**CITY OF TEMPE  
DEVELOPMENT REVIEW COMMISSION**

**Meeting Date: 5/14/2019  
Agenda Item: 5**

**ACTION:** Request two (2) Use Permits to allow restaurant uses and general retail and service uses for **CIRCA '78**, located at 1803 East Rio Salado Parkway. The applicant is DA-OB, LLC.

**BACKGROUND INFORMATION:** **CIRCA '78 (PL190061)** is an adaptive reuse project located on Lot 36 of the Tri City Industrial Area subdivision in the GID, General Industrial District. The applicant, DA-OB, LLC, is proposing a future restaurant tenant in the endcap portion of the building fronting Rio Salado Parkway. The remaining tenant spaces will likely include general retail and service, office, and craft manufacturing uses. The applicant is seeking to first complete the adaptive reuse shell improvements to attract a flexible mixture of uses. The overall project scope includes a concurrent Minor Development Plan Review application for site, landscape, and exterior elevation improvements which is currently under review at a staff/administrative level. The request includes the following:

**Elevations**  
scale: as noted

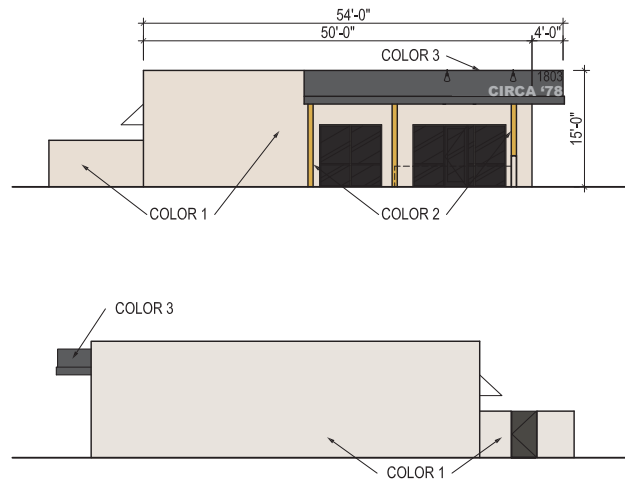
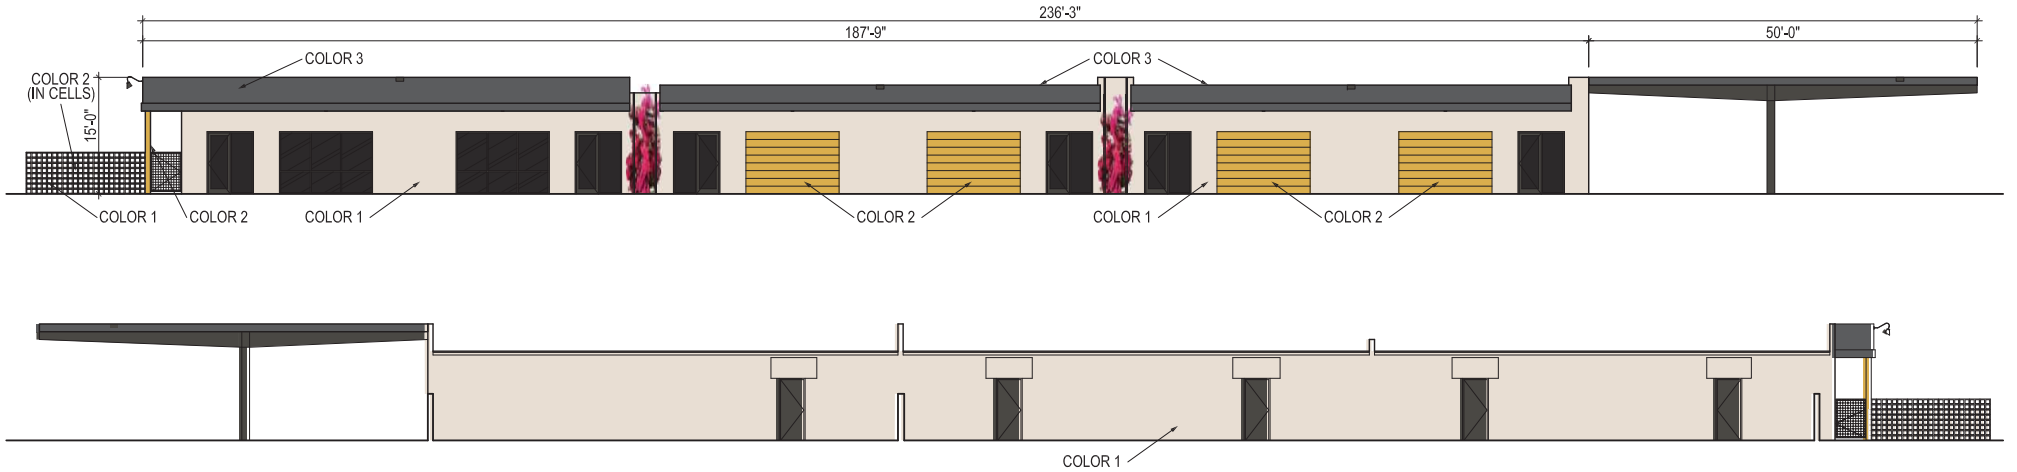
The proposed elevation modifications consist of a new store front installation along the west end of the north elevation and the north end of the west elevation, replacement of the mansard asphalt shade canopy located along the west elevation with vertical metal roofing panels with patterned reveals/seams, and an extension of the shade canopy over a portion of the new patio on the west end of the north elevation. The remaining suites will retain the existing metal roll-up garage doors; however, as the tenant mix changes and tenant improvements are provided, it is anticipated that the roll-up doors will eventually be replaced with either new store front systems, glass folding or roll-up doors, or other refined design concepts that complement the site.

4. *Compatibility with existing surrounding structures and uses;* while the proposed site, landscape, and building elevation modifications are an improvement from the existing conditions, staff recommends additional design considerations that better compliments surrounding restaurant and retail uses such as extending the proposed shade canopy across the entirety of the north building elevation, and incrementally replacing existing metal roll-up doors with storefront systems, glass folding/glass roll-up doors, or other refined design concepts. Additionally, the restaurant and retail uses are consistent with Tempe Marketplace across the street and the new retail shopping center proposed further east on Rio Salado Parkway.

- a. **Extend the shade canopy across the entirety of the north end of the building.**

- b. **With all subsequent tenant improvements, metal roll-up doors shall be replaced with either new store front systems, glass folding/glass roll-up doors, or other refined design concepts that complement the restaurant and/or retail uses.**
- 7. **New employee service exit and entrance doors shall be equipped with a security vision panel. Details to be approved through Building Safety Plan Check Review.**
- 8. **Provide a minimum of eighteen (18) bicycle parking spaces per City of Tempe Public Works Department bicycle rack detail T-578 standard or equivalent design. Details to be approved through Building Safety Plan Check Review.**
- 9. **Entertainment, indoor and/or outdoor, is not approved as a part of this request and requires a separate Use Permit.**
